YSIDRO ADDITION TO WICHITA, SEDGWICK COUNTY, KANSAS

RE: SUB 2003-141 - One-Step Final Plat Ysidro Addition

RE: SUB 2003-141 - One-Step Final Plat Ysidro Addition

CASE NUMBER: SUB 2003-141 -- YSIDRO ADDITION

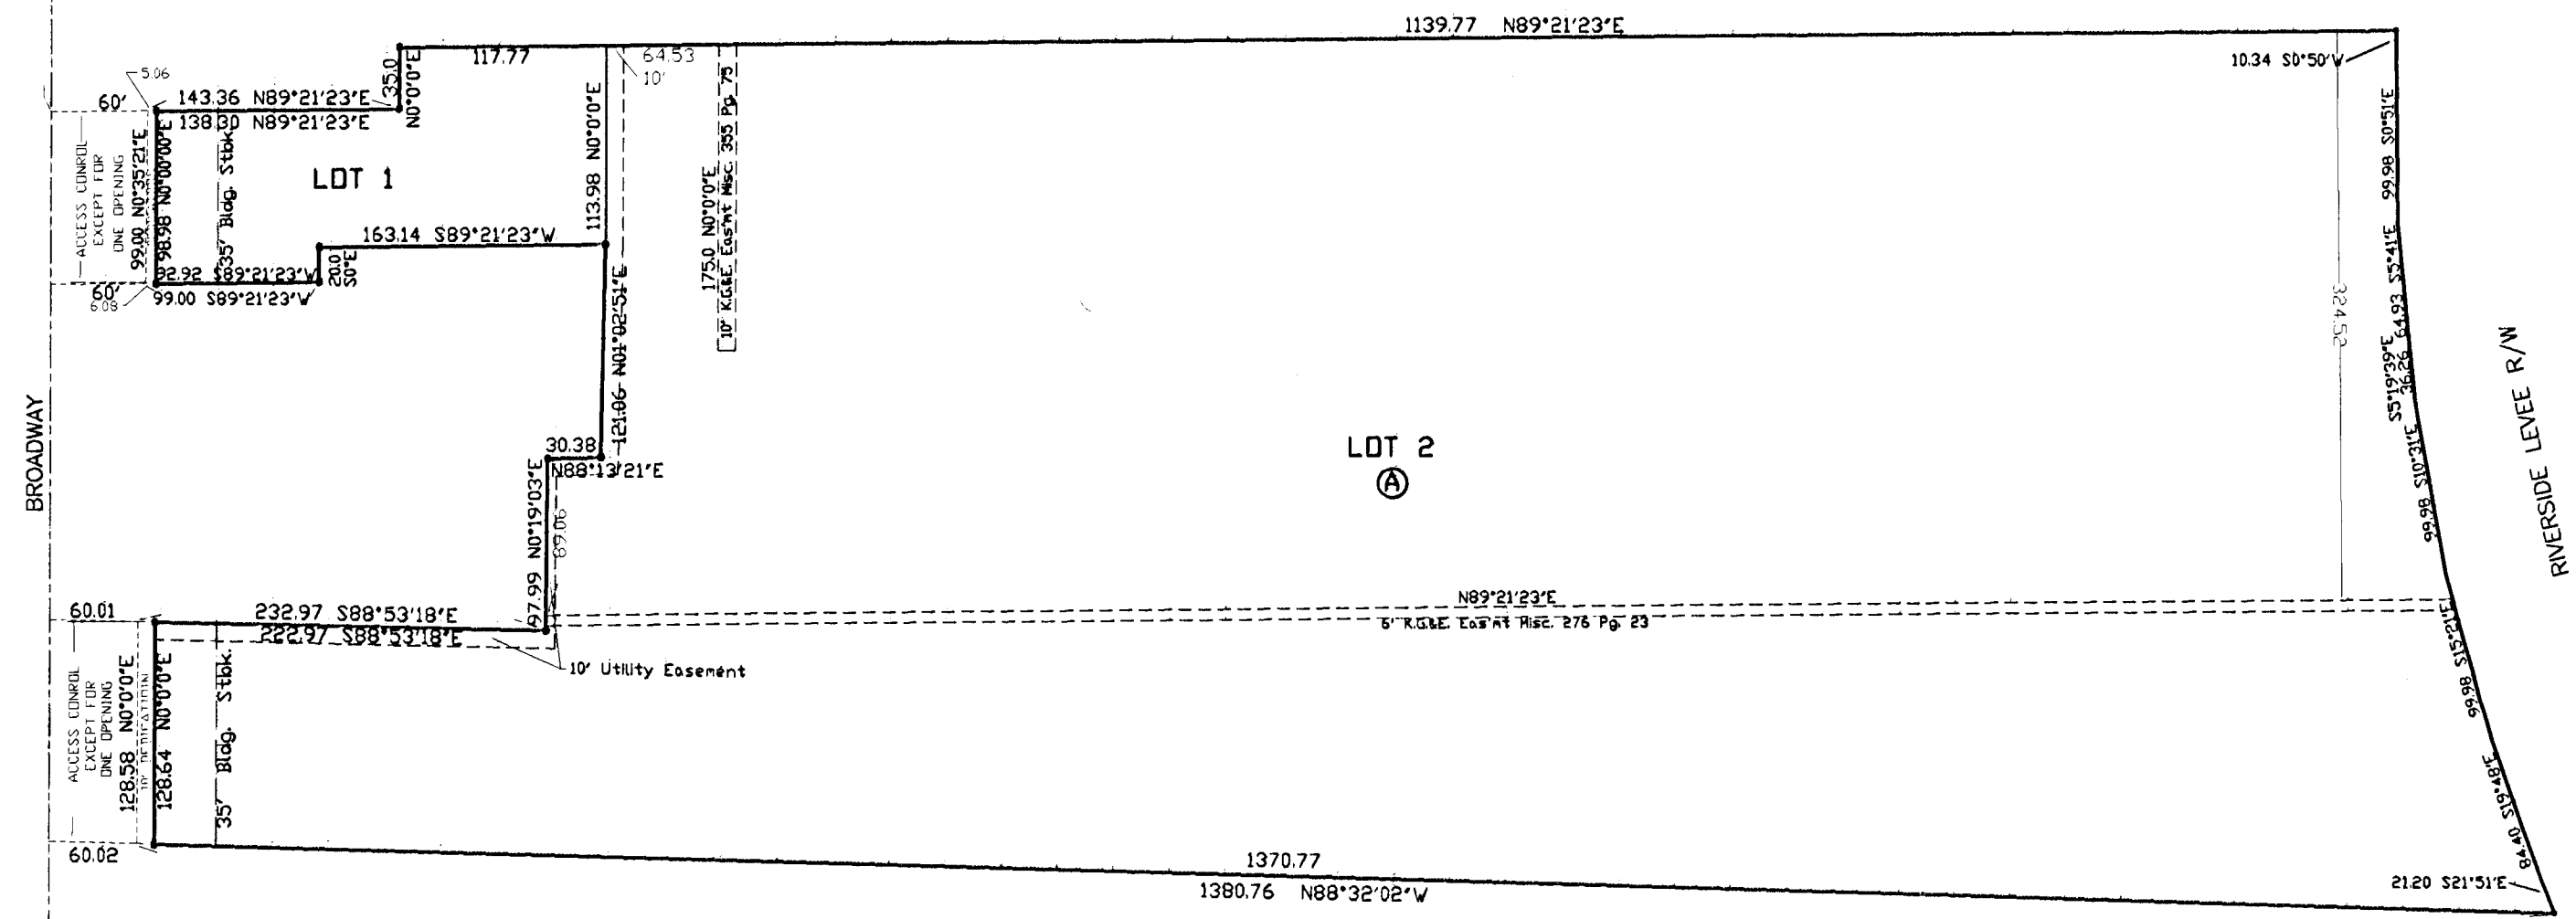
- F. Additional right of way dimensions are needed.
- G. The Riverside levee and Big Arkansas River need to be designated.
- H. The location of the established bank lines needs to be verified if located within the boundaries of the plat.

- I. A lot dimension on Lot 1 is needed.

- J. **Traffic Engineering** needs to comment on the access controls. The plat needs to denote access controls along Broadway on the face of the plat. The plat's text proposes one access opening for each lot. **Traffic Engineering has approved the access controls. A restrictive covenant shall be submitted that permits future cross-lot access with the abutting property owners to the north and south of Lots 1 and 2.**

- K. **Traffic Engineering** has requested additional right-of-way along Broadway. The Access Management Regulations requires a 60-ft half-street right-of-way width along urban arterials.

- N. The signature line for the City Clerk needs to be revised to reference "Karen Schofield".
- O. The year "2004" needs to replace "2003" within the signature blocks.

- Q. A Block shall be designated on the face of the plat as referenced in the plat's text.
- R. The plat's text shall include language that a drainage plan has been developed for the plat and that all drainage easements, rights-of-way, or reserves shall remain at established grades or as modified with the approval of the applicable City or County Engineer, and unobstructed to allow for the conveyance of stormwater.
